APPEAL SUMMARY

Appeal ID: 19031

Building/Business Name: Multnomah County Health Headquarters

LUR or Permit Application No.: 16-227322-CO

Drawing Title
LIFE SAFETY
PLANS

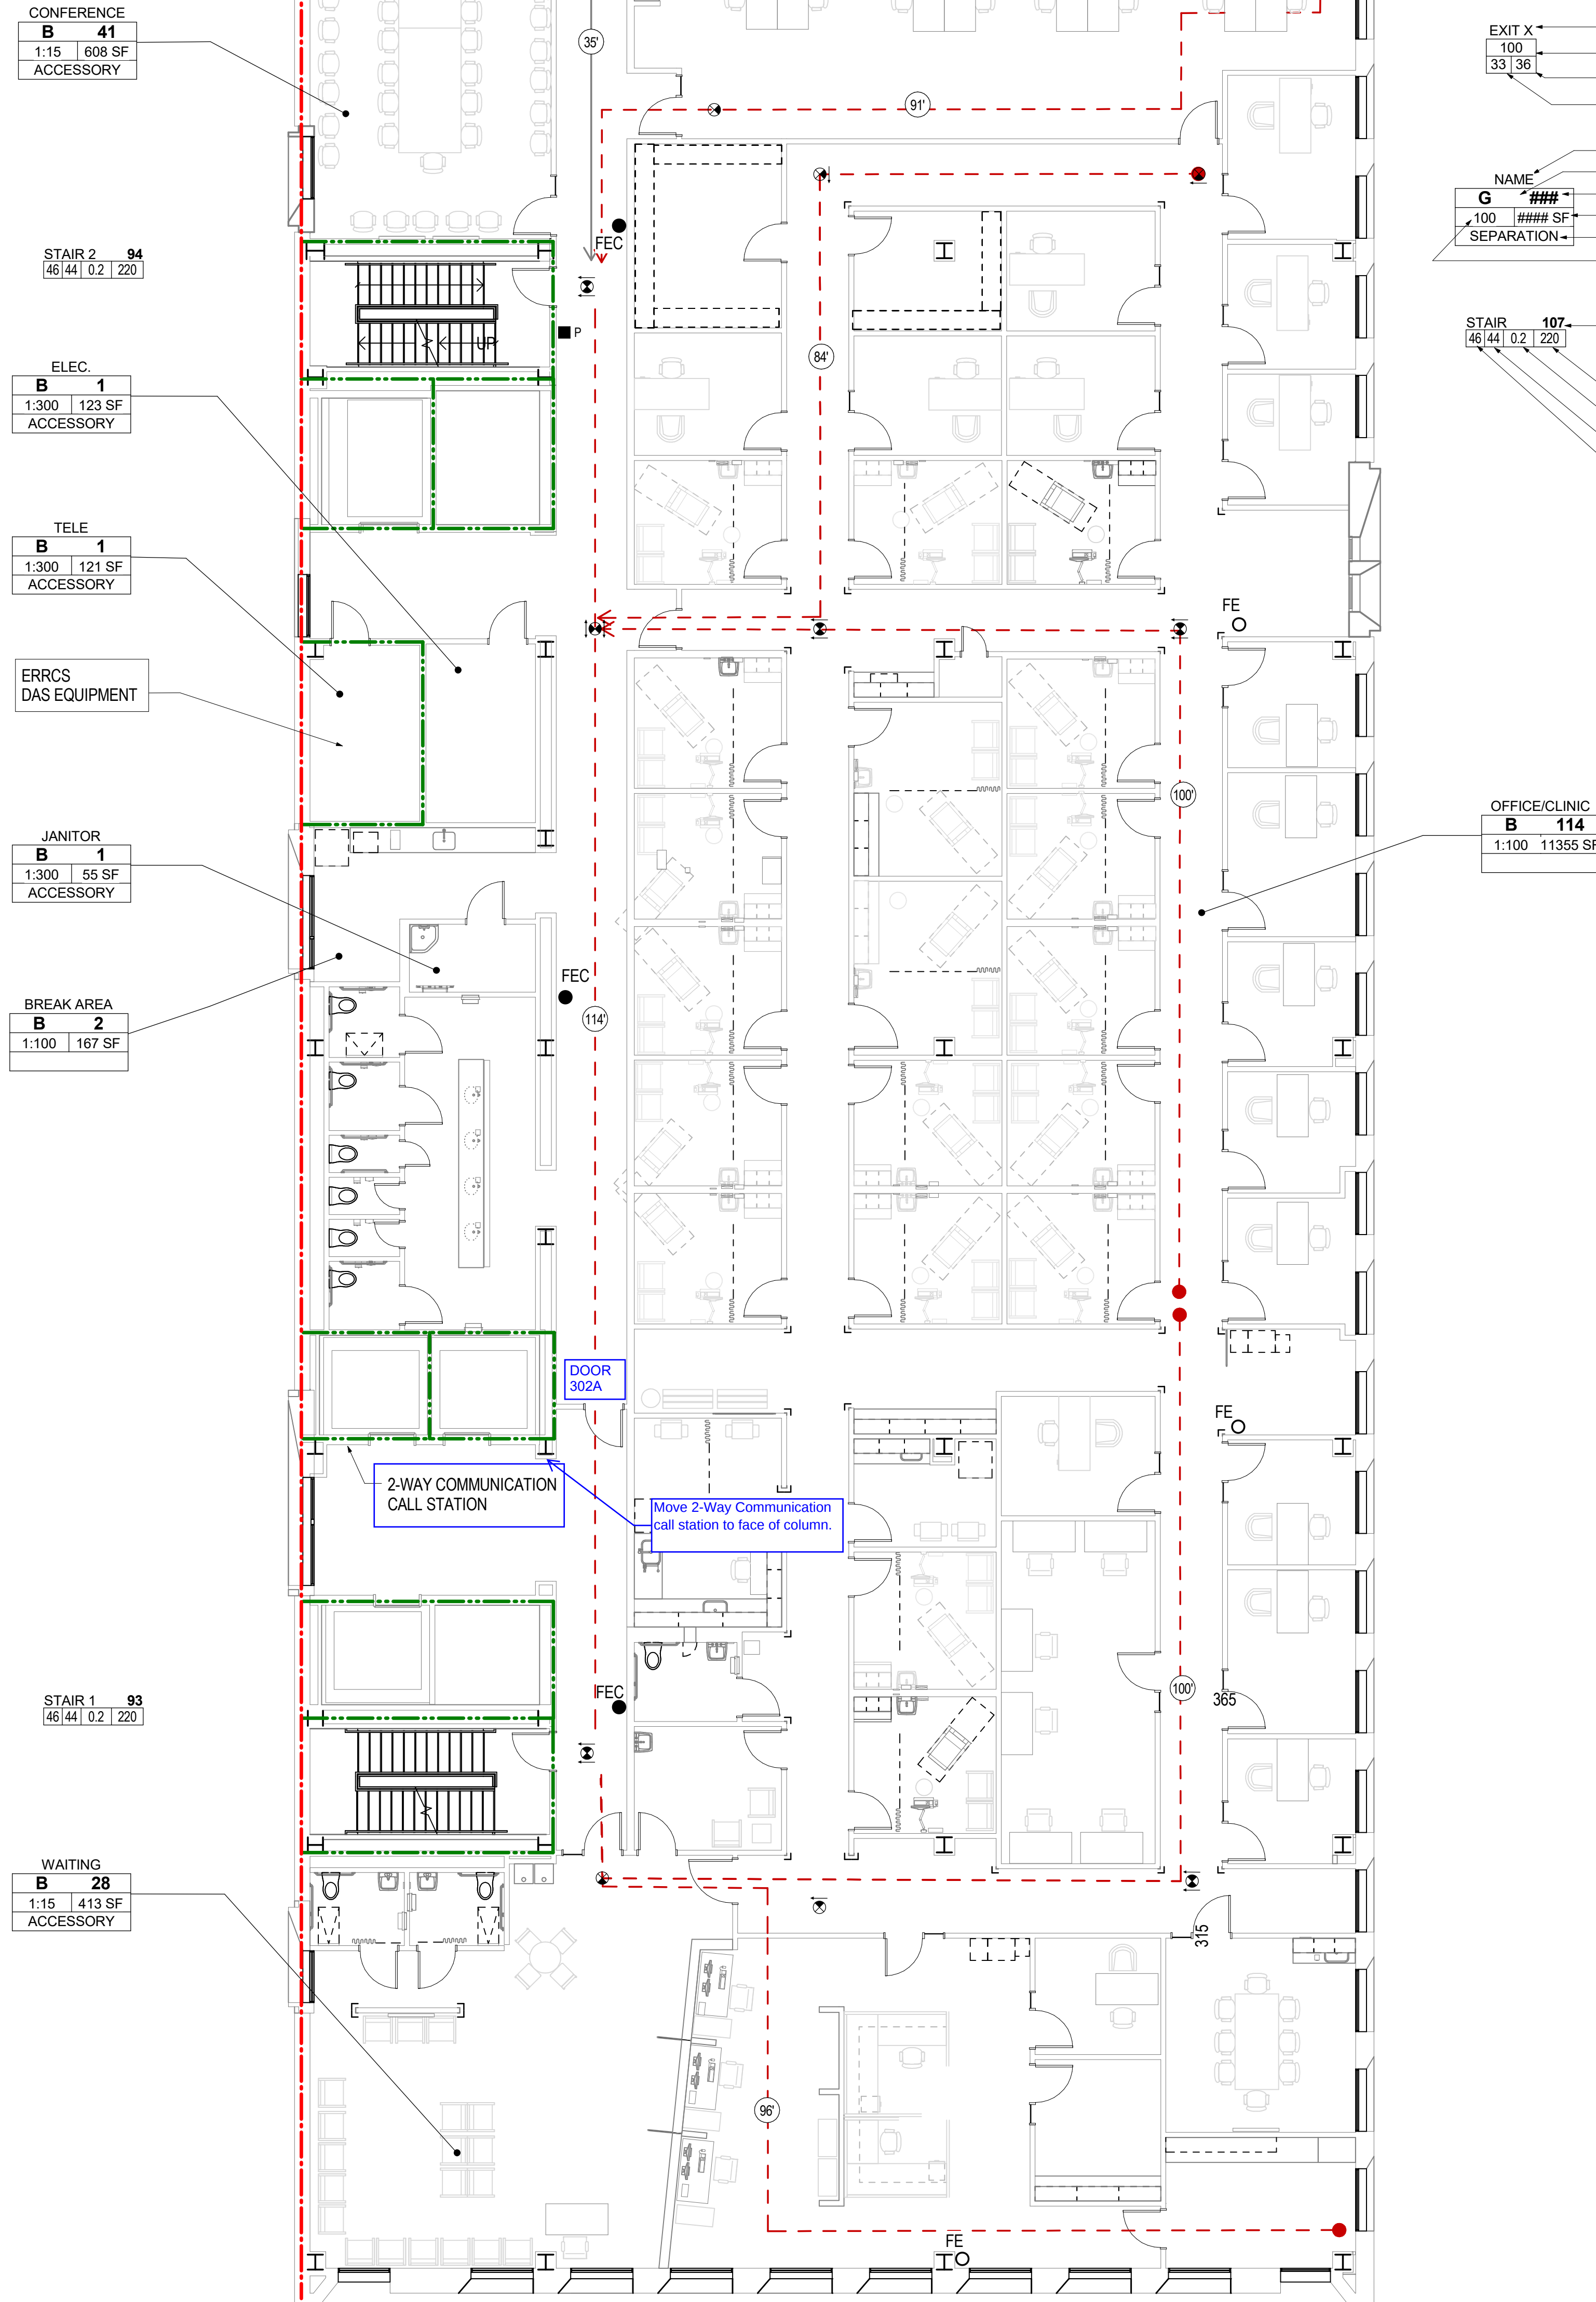
The cross-corridor doors 202A, 302A, 402A, 502A, 602A, 702A, 802A and 902A currently allow free access for exiting from the north to the south but are card reader access from south to north. We propose that the door hardware be revised to release the lock on fire alarm allowing egress from south to north as well.

Rather than adding 2-way communication devices at the doors, there are 2-way communication devices located 20 ft. to the west of the doors, in the Elevator Lobbies. These devices are connected to the County's Alarm Control Station which is manned 24 hours per day, 7 days per week. Signs will be provided next to the doors directing attention to the 2-way communication

The 2-way communication call box will be located within 5 ft. of the cross corridor door. See revised Exhibit B plans attached.

Release of access controlled egress doors by fire alarm signal or loss of power: Granted as proposed.
